ADDENDUM NUMBER 3

NOTIFICATION DATE:	BID TITLE:	BID NUMBER:	BID OPENING DATE & TIME:
01/15/16	Central Avenue Improvements - Construction	16-012	NEW 01/20/2016 2:00PM

Addendum 3 - Exhibit C – REVISED PLAN SHEETS, 2, 2A, 9, 10, 11, T-2, T-3 & T-4

SHEET NO. T-3

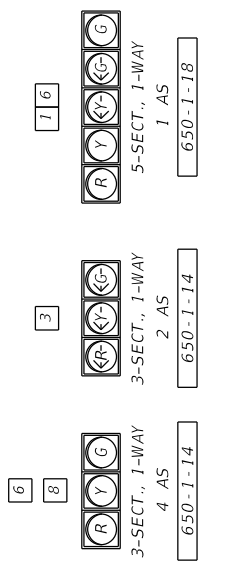
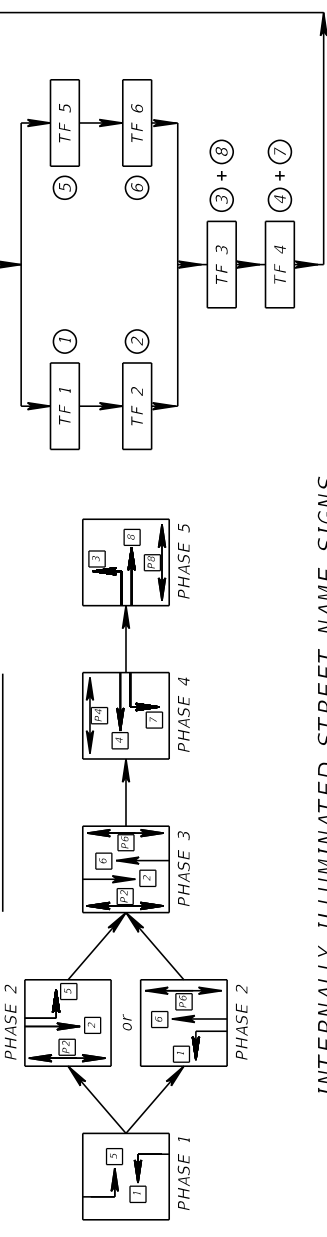
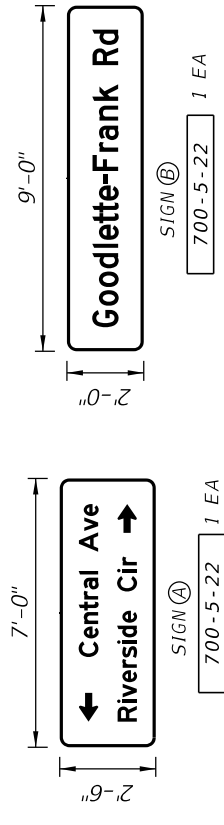
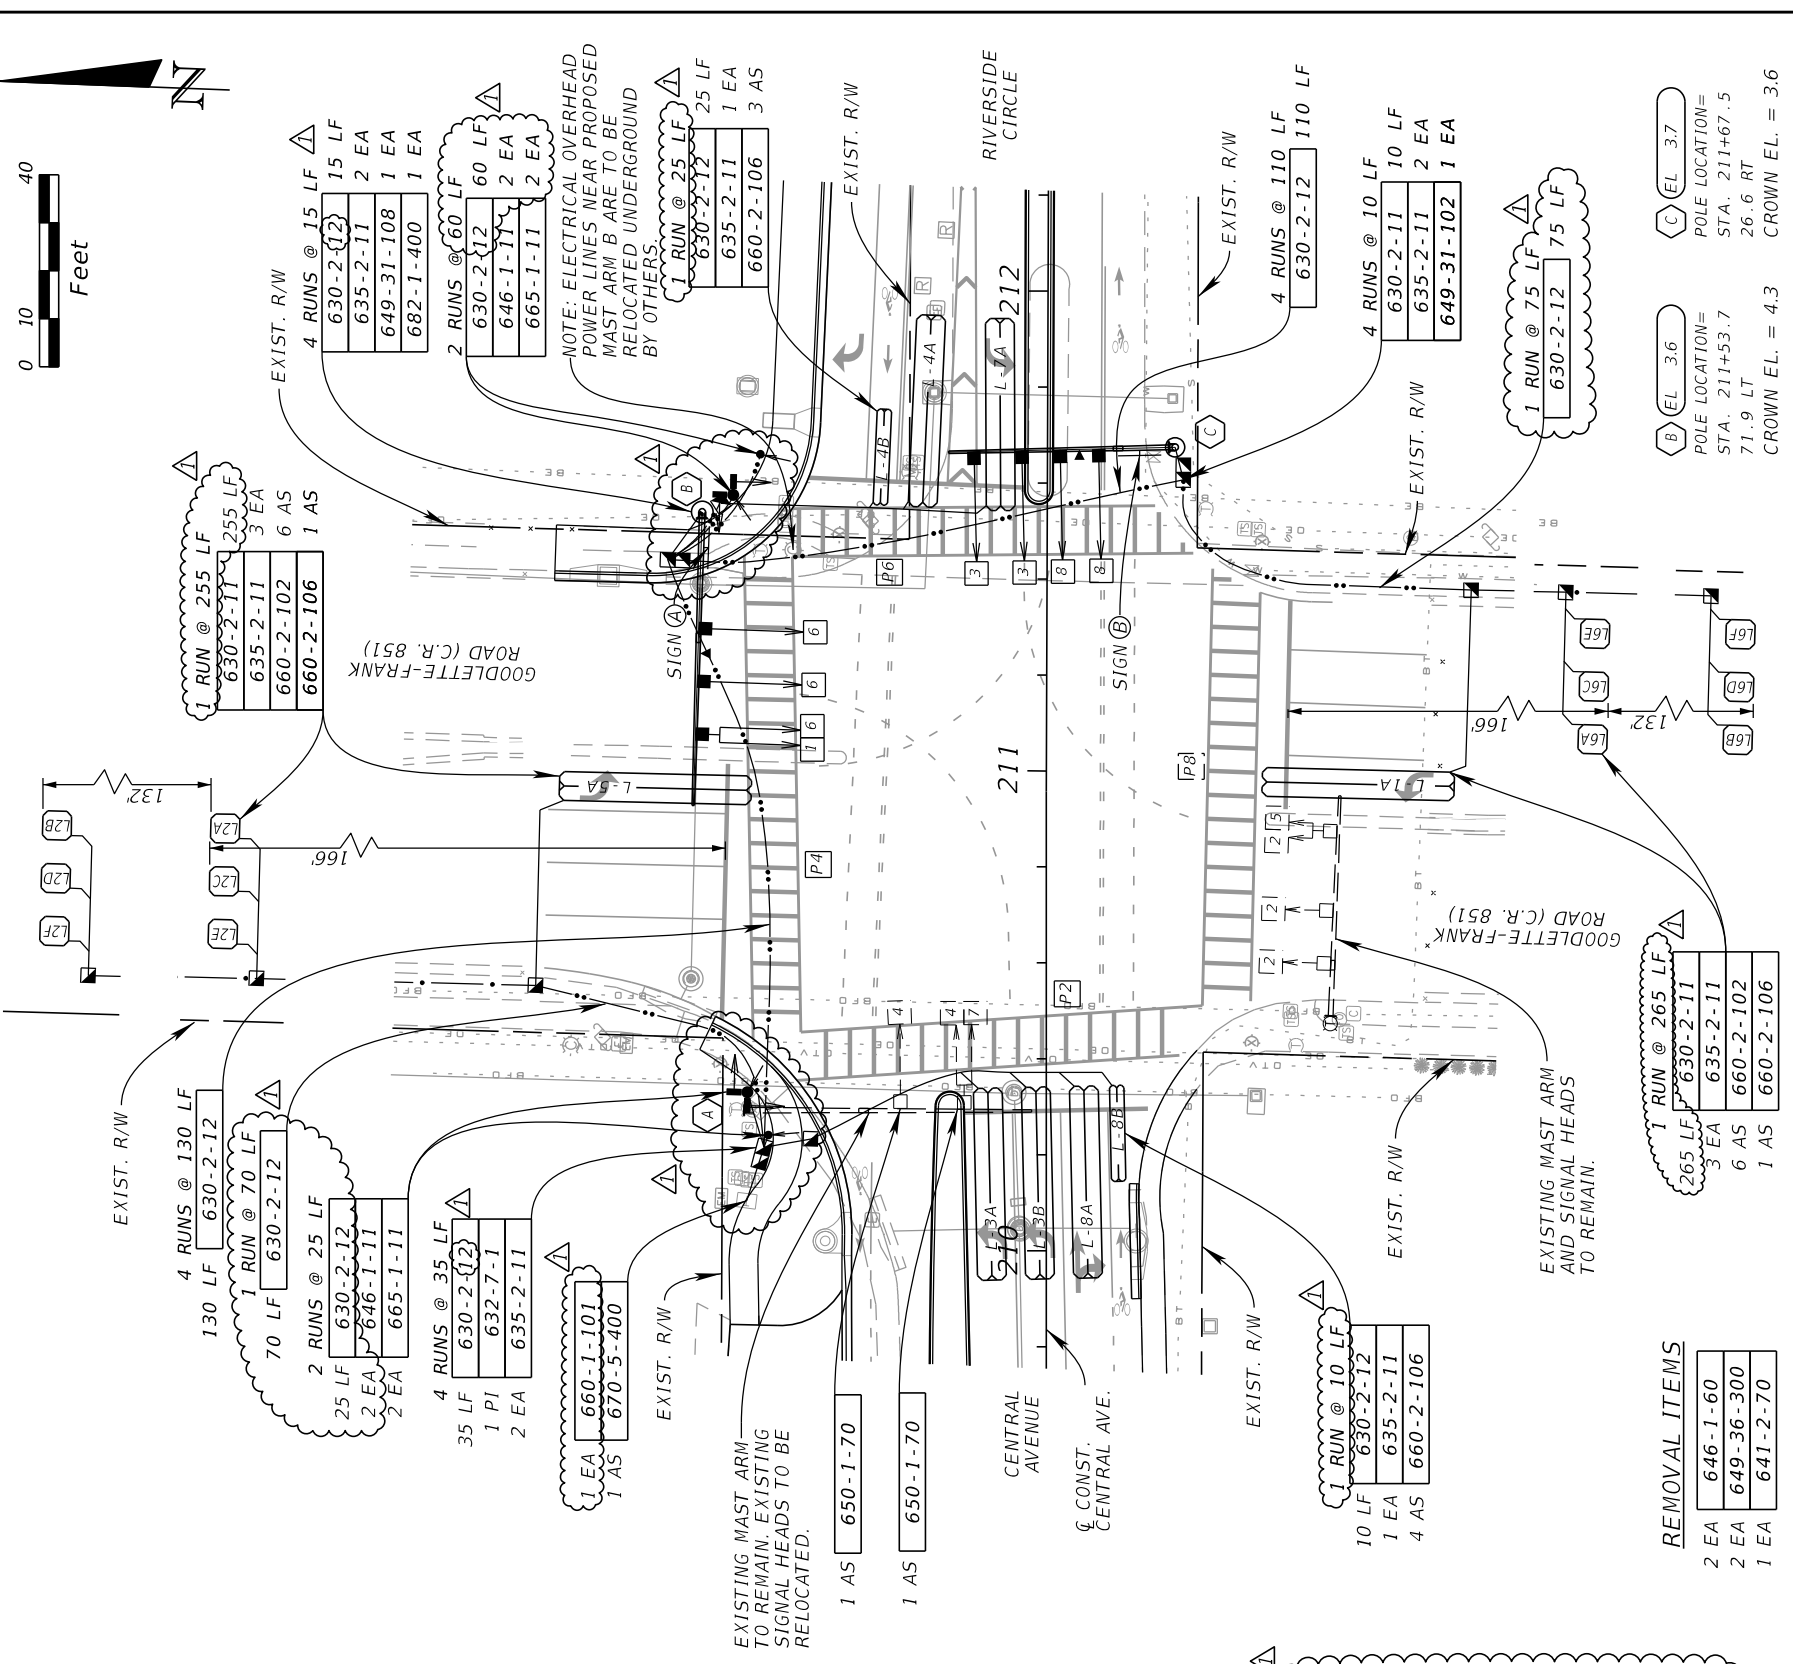
- 1) Detectors for Loops Table indicates new detectors but no new Pay-Item exist for same; how will the NEW detectors be paid for.

- 4) Dave Rivera reviewed the Signal plans and noted that the plans call for 1EA of the Central/Riverside sign and Goodlette sign where 2 will be necessary (with arrows reversed on Central/Riverside sign). Also, the pedestrian push buttons will need to be 10' apart but the plans appear to show them next to each other. He also had a phasing comment that I think we can address down the road.

Answer- Plan sheet T-2, T-3 and sheet 2 have been revised to reflect the appropriate number of detectors including the addition of a new pay. Plans have been clouded to reflect the modified information.

2) Pedestrian signal poles and conduit quantities have been modified to reflect the necessary 10ft. separation. Plan sheets have been revised to address additional quantities and other revisions as necessary.

DATE	DESCRIPTION	DATE	DESCRIPTION
01/15/16	REVISOR: THE DETECTORS, ADDED MORE PED FEATURES, AND UPGRADED SEVERAL CONDUIT RUNS TO 630-2-12.
